Liberty School District – Baseball Sotball Complex
Addendum No: 004
Description Narrative
August 04, 2023

ADDENDUM NO. 04

Project: LHS/LNHS Baseball and Softball Field Upgrades

Project No. 23023/23047

P1 Scale 3/16" = 1'-0" — Front Elevation - Away Dugout

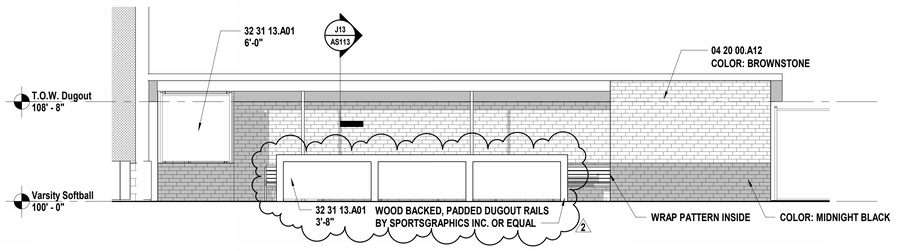
A10.3 ADD padded dugout rails to drawing Q10 and P1.

A1 Scale 1/16" = 1'-0" — Varsity Softball

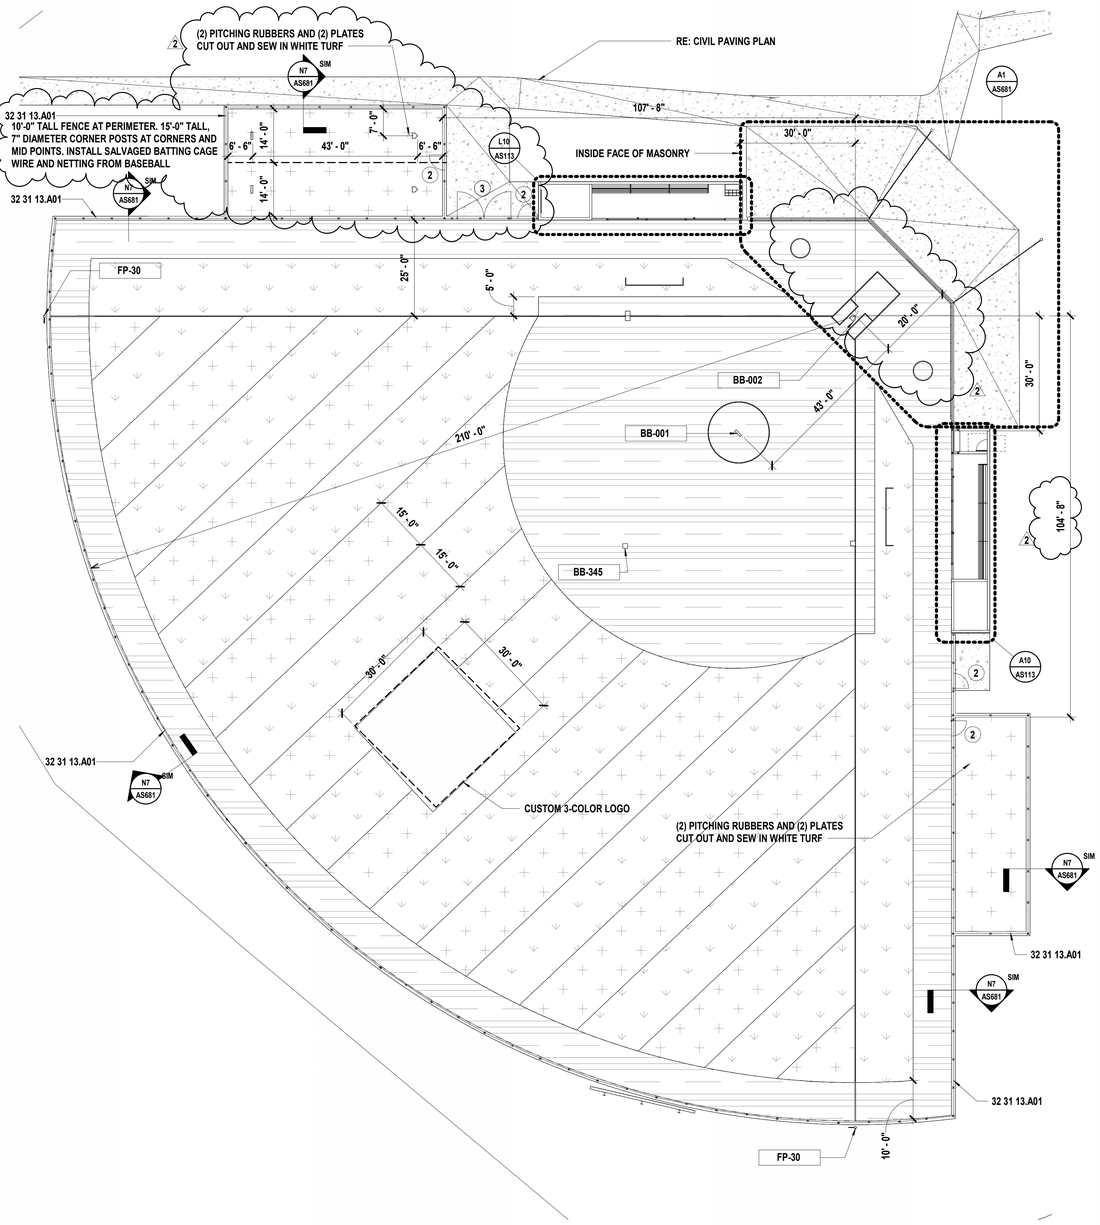
A10.4 ENLARGE 1st base side bullpen to accommodate width for two batting lanes in order that salvaged batting cage material can be reinstalled from existing baseball facility at drawing A1. ADD dimensions for recommended placement of sewn in home plate and pitching

A10.5 REDUCE area behind home plate to be 20'-0" in lieu of previously shown 25'-0" dimension at drawing A1.

A10.6 ADD 3'-0" in length to 3rd base bullpen. The updated dimension from home plate can be found clouded at drawing A1.

L10 Scale 3/16" = 1'-0" — Enlarged Dugout Plan - Home

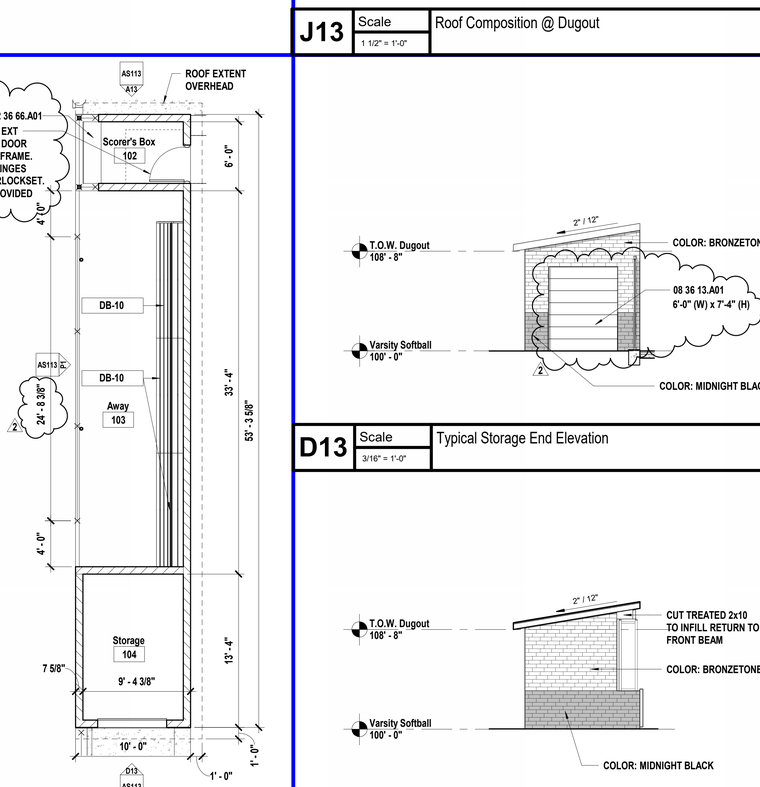
A10.2 ADD dimensions to fence layout on drawing L10.

J1 Scale 3/32" = 1'-0" — Enlarged Plan - 40' Netted Backstop @ Baseball

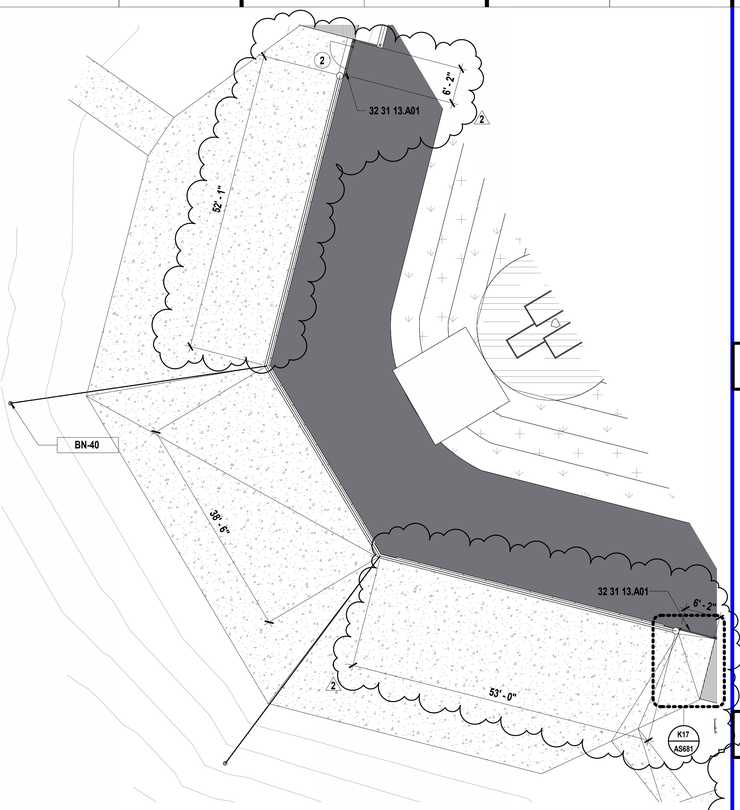
A11.4 ADD chain-link fence portions and REVISE backstop netting dimensions at drawing J1.

A6 Scale 1/32" = 1'-0" — Perimeter Concrete Turf Curb @ Softball

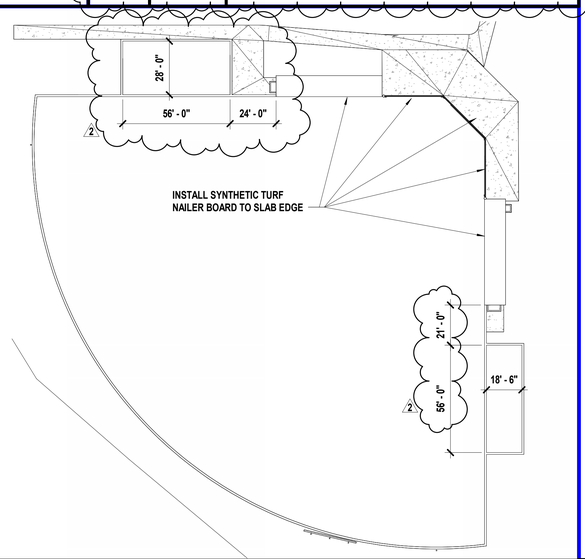
A11.2 REVISE curb dimensions on Drawing A6 that coordinate with the enlarged bullpens

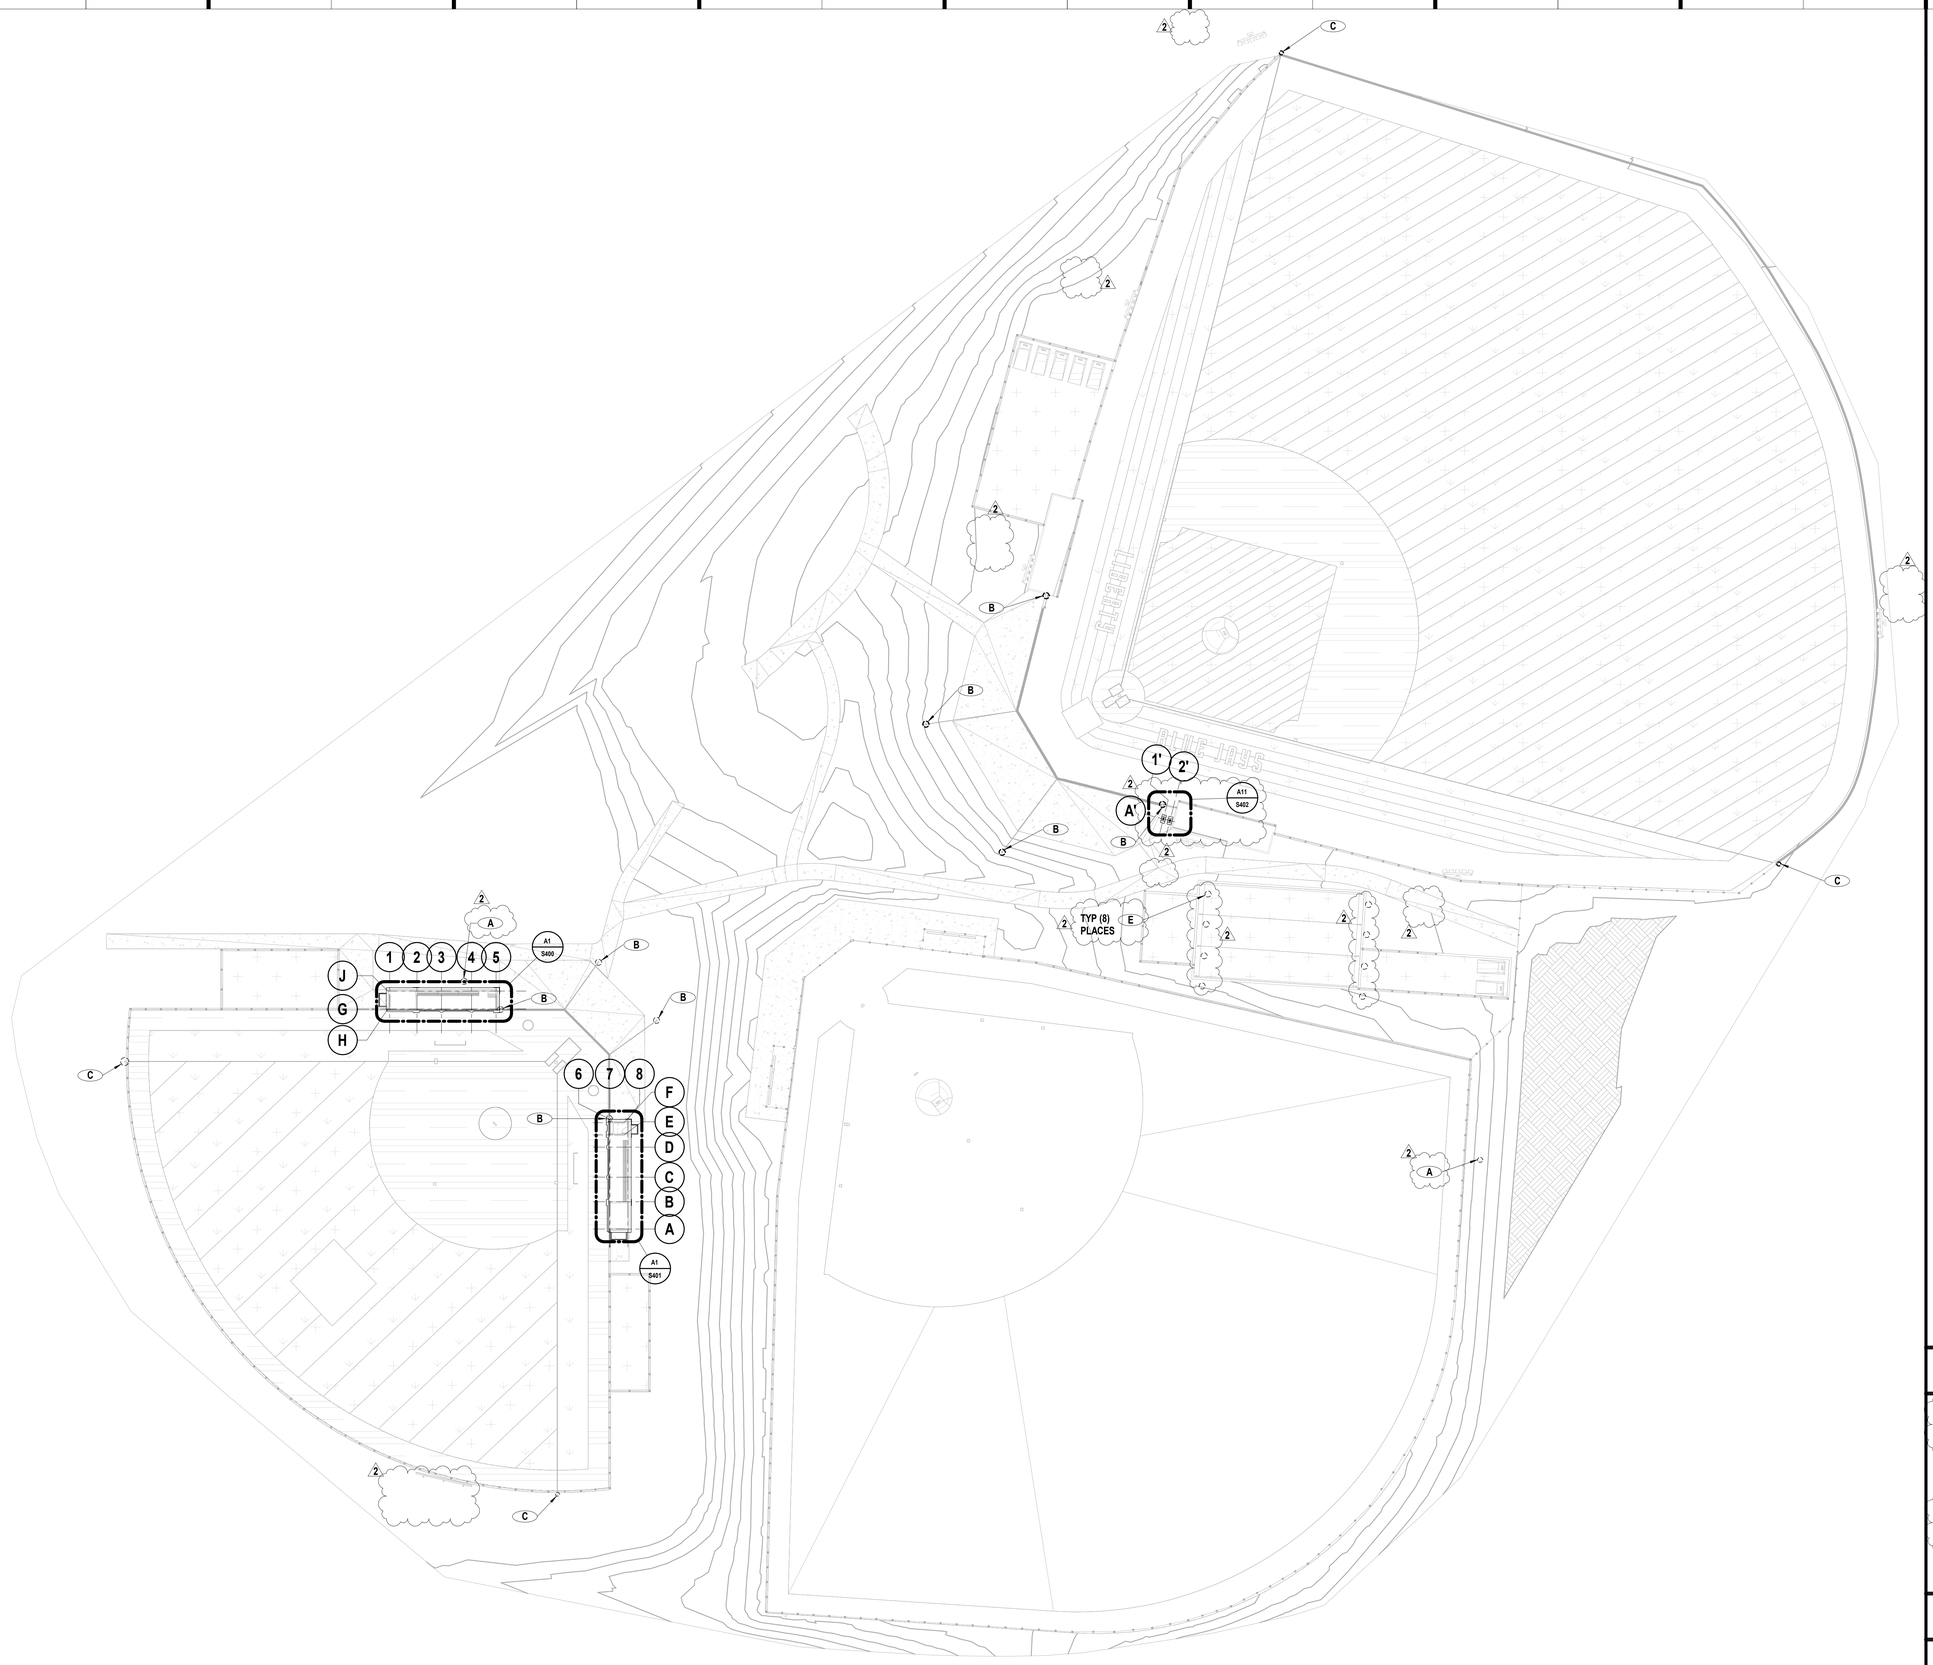
S2.1 REMOVE plan reference notes at existing equipment.

S2.2 ADD plan note A to relocated light pole locations.

S2.3 ADD plan note E at batting tunnel footings.

S2.4 ADD callout A11/S402 at scorer's box alternate.

S2.5 REVISE plan reference note A to read the following: "Exist 70' Musco light pole to be relocated. Provide new pole footing per light pole mfr. RE M301."

S2.6 REMOVE plan reference note D

S2.7 ADD plan reference note E: "Batting tunnel footing per J9/S530."

A1 Scale 3/4" = 1'-0" Wall Section

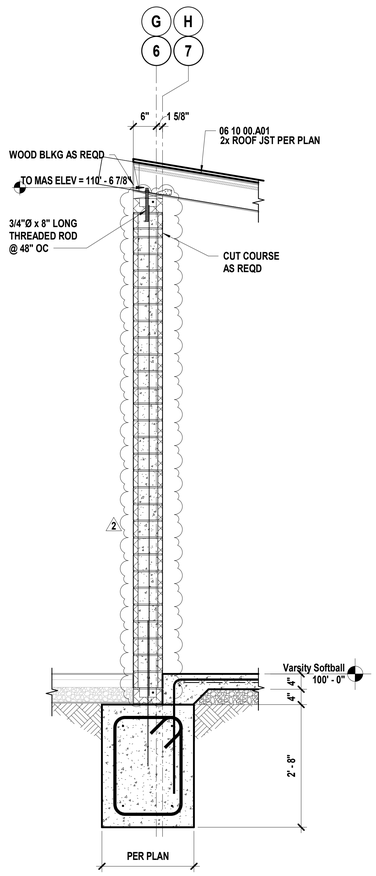
S3.1 REVISE A1/S310 to graphically show 4" structural clay masonry wall structure.

A5 Scale 3/4" = 1'-0" Wall Section

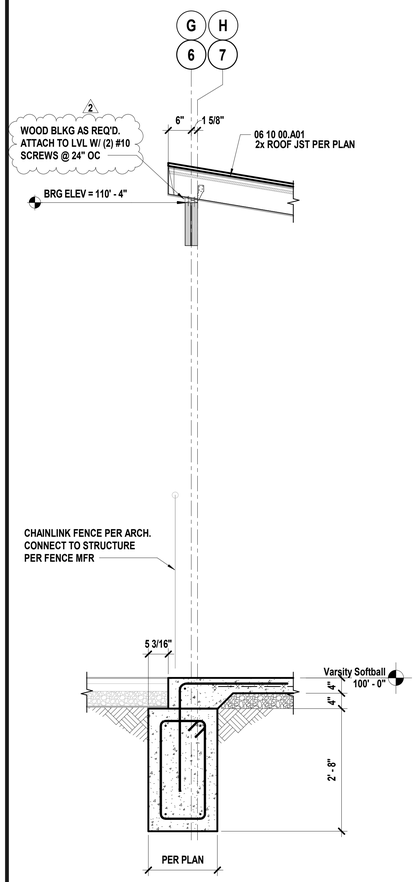
S3.2 ADD wood blocking and attachment above (2) LVL beam at A5/S310.

A9 Scale 3/4" = 1'-0" Wall Section

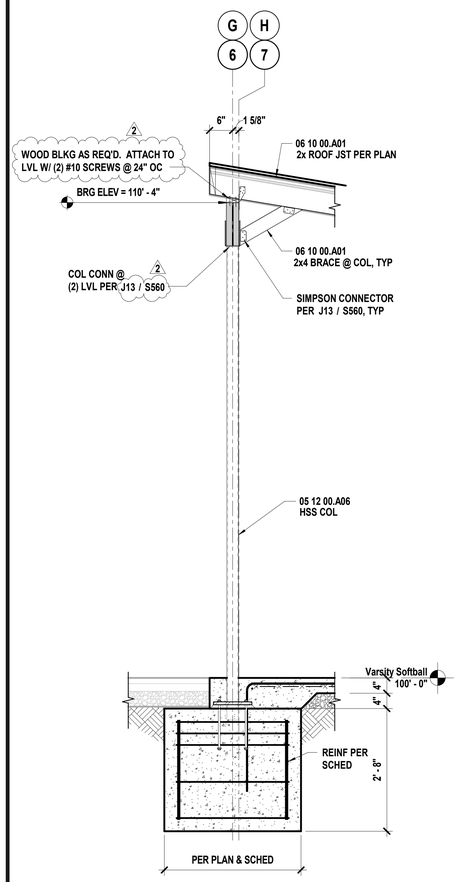
S3.3 ADD wood blocking and attachment above (2) LVL beam at A9/S310.

S3.4 REVISE note at A9/S310 to read the following: "Col conn @ (2) LVL per J13/S560."

A13 Scale 3/4" = 1'-0" Wall Section

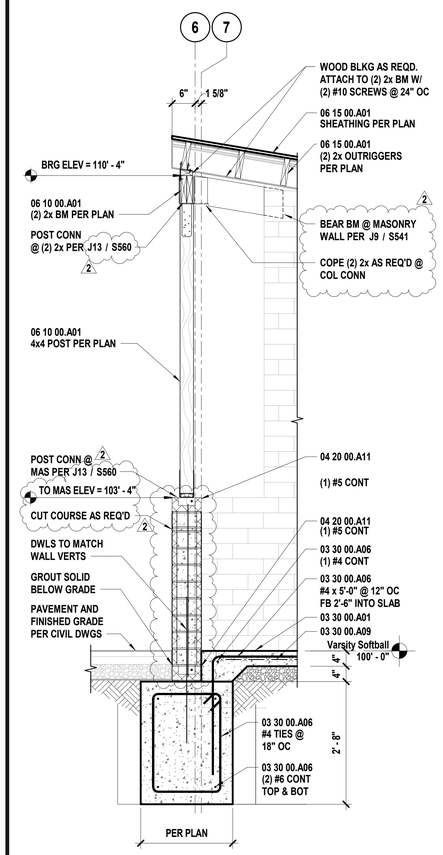
S3.5 REVISE A13/S310 to graphically show 4" structural clay masonry wall structure.

S3.6 ADD top of masonry wall elevation callout at A13/S310.

S3.7 ADD note to A13/S310 as follows: "Cut course as req'd."

S3.8 REVISE note at A13/S310 to read the following: "Post conn @ (2) 2x per J13/S560."

S3.9 ADD note to A13/S310 as follows: "Bear bm @ masonry wall per J9/S541."

S3.10 ADD note to A13/S310 as follows: "Cope (2) 2x as req'd @ col conn."

L13 Scale 3/4" = 1'-0" — Wall Section

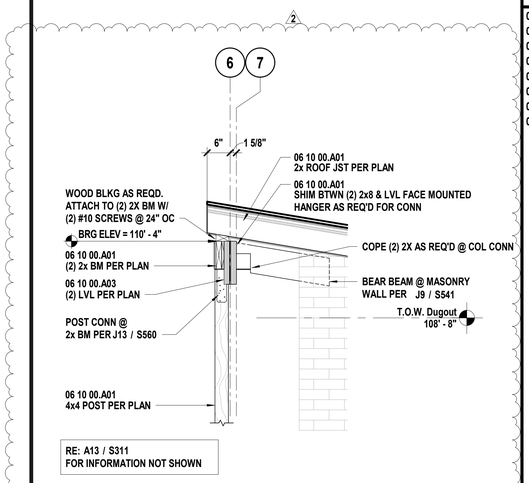
S4.7 ADD L13/S311 to show connection at top of wood 4x4 post.

A1 Scale 3/4" = 1'-0" — Wall Section

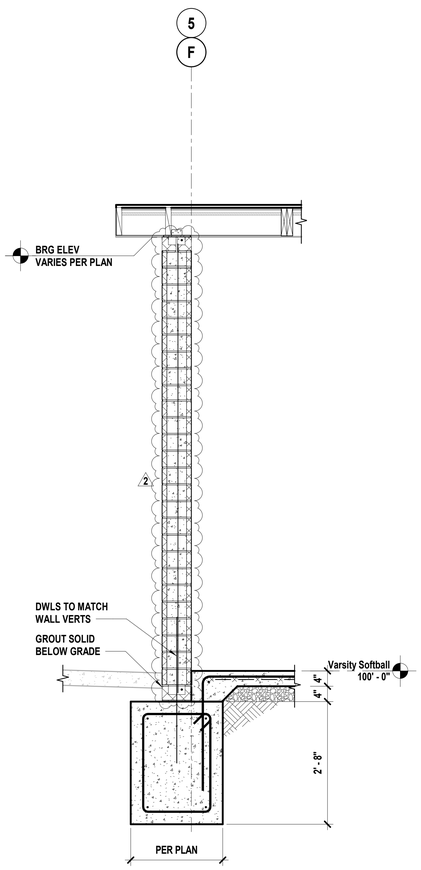
S4.1 REVISE A1/S311 to graphically show 4" structural clay masonry wall structure.

A5 Scale 3/4" = 1'-0" — Wall Section

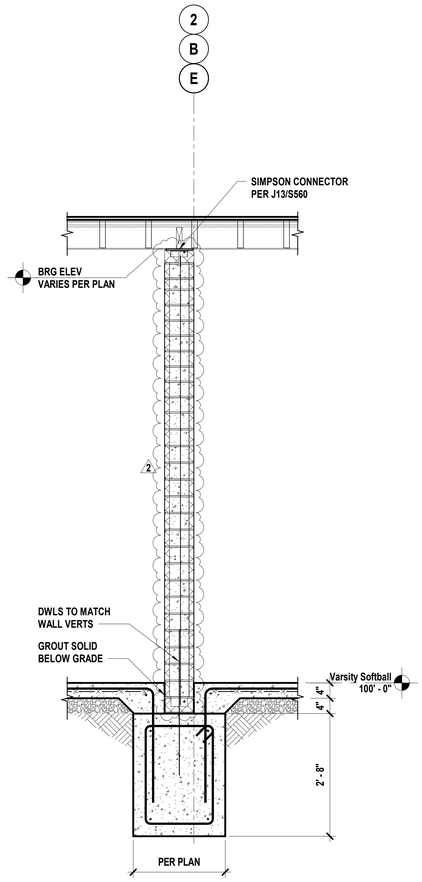
S4.2 REVISE A5/S311 to graphically show 4" structural clay masonry wall structure.

A9 Scale 3/4" = 1'-0" — Wall Section

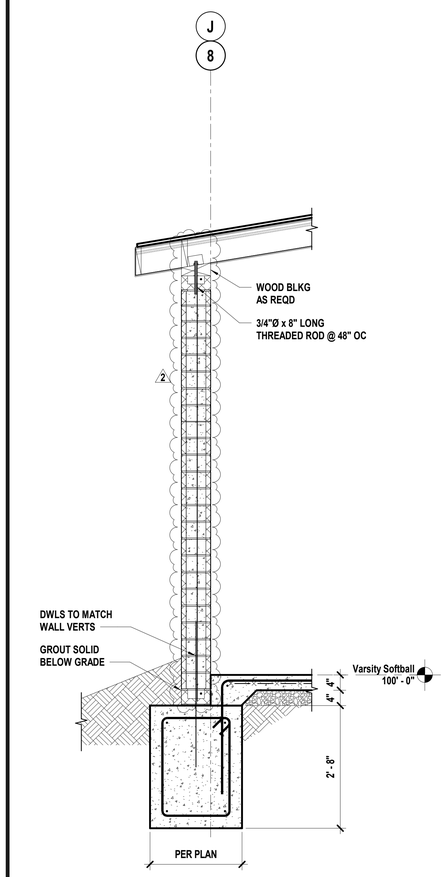
S4.3 REVISE A9/S311 to graphically show 4" structural clay masonry wall structure.

A13 Scale 3/4" = 1'-0" — Wall Section

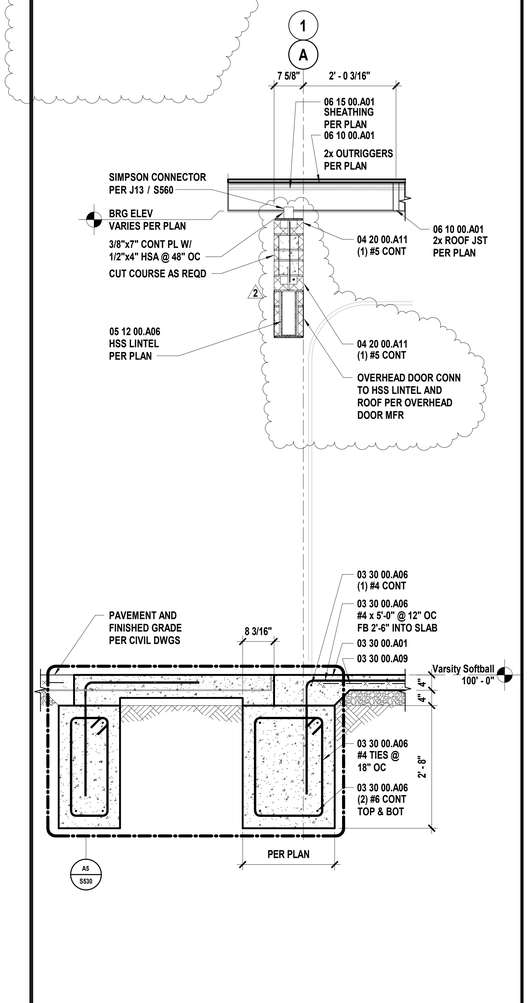
S4.4 REVISE A13/S311 to graphically show 4" structural clay masonry wall structure.

S4.5 REVISE note to A13/S311 to read the following: "Overhead door conn to HSS lintel and roof per overhead door mfr."

S4.6 REMOVE roof joist size note at top left of A13/S311.

J1 | Scale 3/8" = 1'-0" | North Dugout Roof Framing Plan

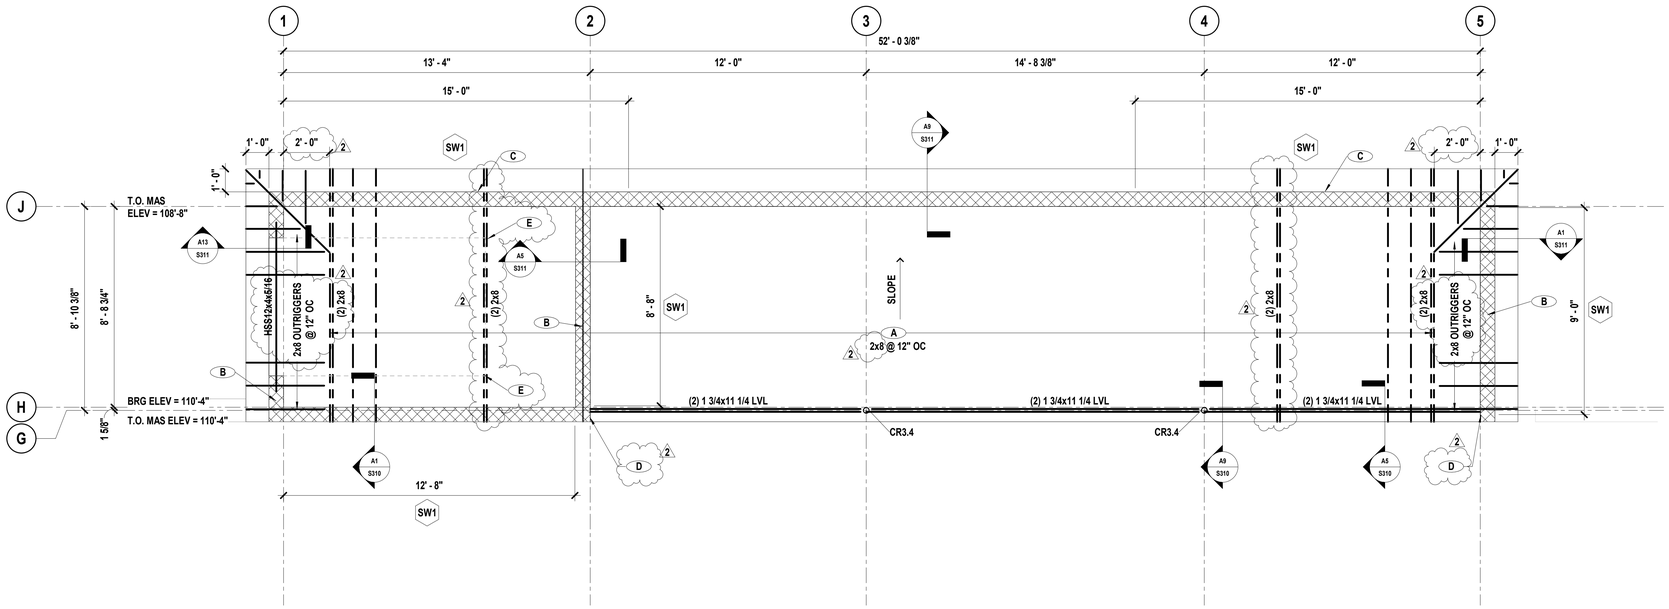
S5.4 REVISE HSS lintel size on J1/S400 to HSS12x4x5/16.

S5.5 REVISE wood joist and outrigger sizes on J1/S400 to 2x8 @ 12" OC.

S5.6 REVISE wood joist size at outrigger connection to (2) 2x8 on J1/S400 and dimension to joist from gridlines.

S5.7 ADD (2) 2x8 and plan reference note E at overhead door connection on J1/S400.

S5.8 ADD plan reference note D at LVL bearing connection to masonry walls on J1/S400.
